MIL-M-28787/54B
AMENDMENT 1
16 December 1992

MILITARY SPECIFICATION

MODULES, STANDARD ELECTRONIC

RECEIVER, INTERFACE, DIGITAL, KEY CODE QDH

FIGURE 6. Isolation test circuit for table IV.

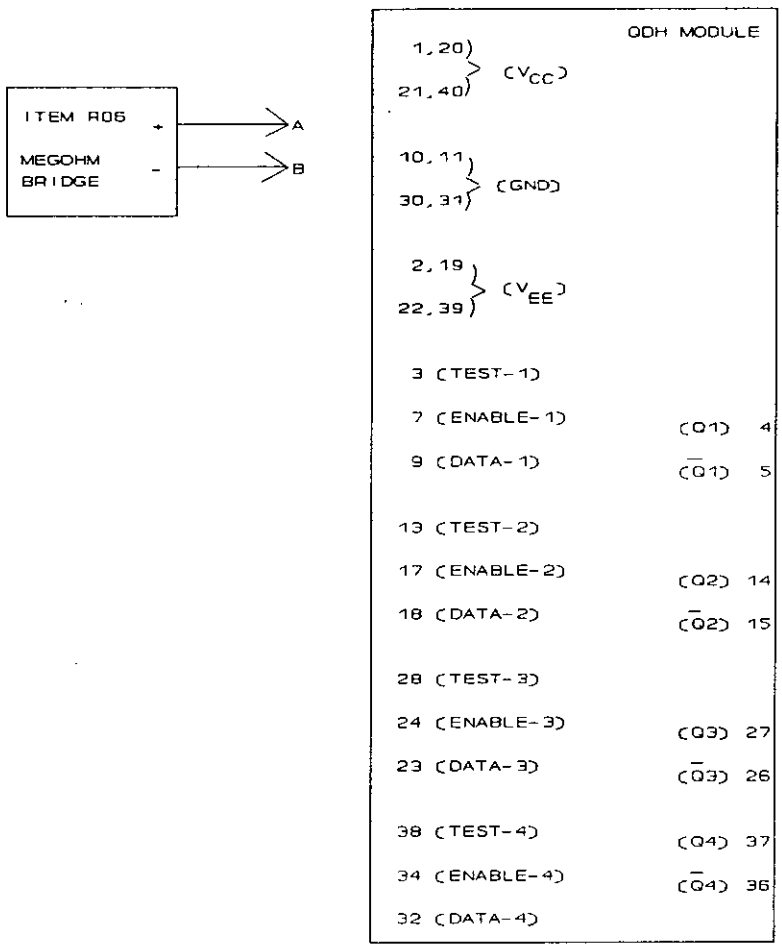
FIGURE 6: Delete and substitute new figure 6 as printed on page 3 of this amendment.

When using a megohm bridge, high voltage may be present at any of the output binding posts. Always set the megohm bridge function switch to "discharge" before connecting or disconnecting the test leads.

1. On test condition B2, (when measuring to frame) penetrate the anodized finish of the module frame with a sharply pointed probe connected to the negative terminal.

2. For test condition B1, the megohm bridge voltage shall be 30 ± 3 Vdc.

3. For test condition B2, the megohm bridge voltage shall be 100 ± 10 Vdc.
